IN THE DRAWINGS

REMARKS/ARGUMENTS

Applicants have studied the Office Action dated June 13, 2005 and have made amendments to the claims. It is submitted that the application, as amended, is in condition for allowance. Claims 4-5 and 15 have been cancelled without prejudice. By virtue of this amendment, claims 1-3, 6-14 and 16-20 are pending. Claims 1, 6-9, 12, and 16-18 are amended. Reconsideration and allowance of the pending claims in view of the above amendments and the following remarks is respectfully requested.

FIG. 2

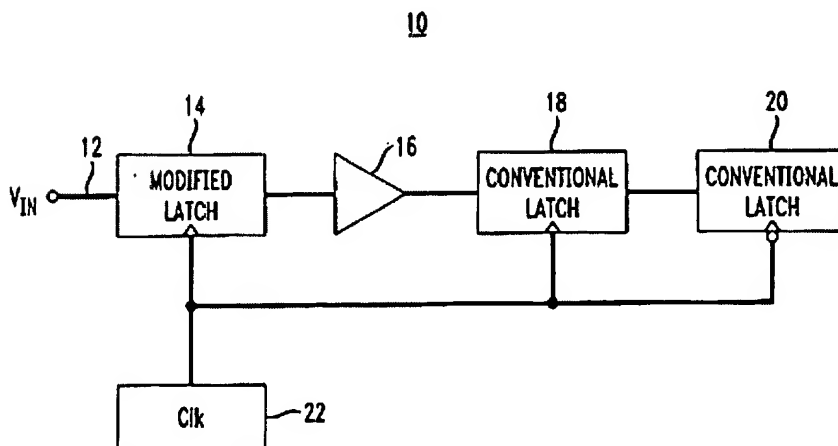
Each of the latches (14, 18, & 20) of Chen et al. has a sample period and a hold period triggered by signals from an external clock (22). Chen et al., col. 2, lines 25-26. The Chen et al. circuit is shown below:

The Examiner on page 5 of the Office action analogizes conventional latches 18 and 20 of Chen et al. to latch circuit 512 and strobe circuit 300 of the present invention,

respectively. Although it is not mentioned in the specification, the above circuit of Chen et al. shows an important feature that would make any type of a delay element in the clock signal line between conventional latches 18 and 20 of Chen et al. render the circuit inoperable. FIG. 2 of Chen et al. shows an inverter at the clock input to the latch 20. The inverter ensures that while the first conventional latch (18) is holding, the second conventional latch (20) is sampling. When the clock cycle switches, the second conventional latch (20) holds the previously held output value of the first conventional latch (18) and the first conventional latch (18) begins sampling again. A delay element inserted in the clock signal line between the first latch and second latch, as the Examiner suggests would be obvious, would destroy the intent of Chen et al. because the signal previously held by the first latch would be gone by the time the second latch was signaled to hold.

FIG. 1

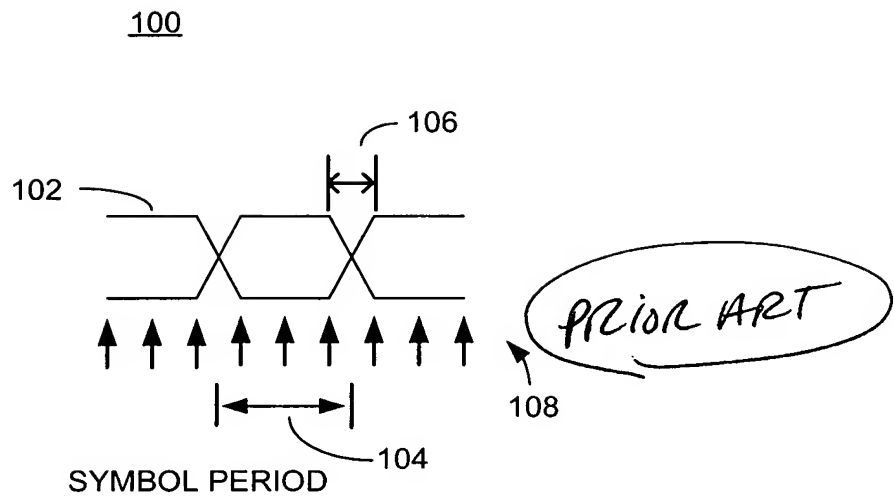
- FIGs. 1-4 add the legend "Prior Art".

As noted above, the Examiner objected to drawings 1-4 under MPEP § 608.02(g) for omitting the legend "Prior Art". In amended Figures 1-4, the previously omitted legend "Prior Art" has been added. As required under 37 CFR 1.84 "Annotated Sheet Showing Changes" and Replacement Sheets are attached hereto. Applicants submit that the Examiner's objections to the Drawings have been overcome and the Examiner's rejection should be withdrawn.
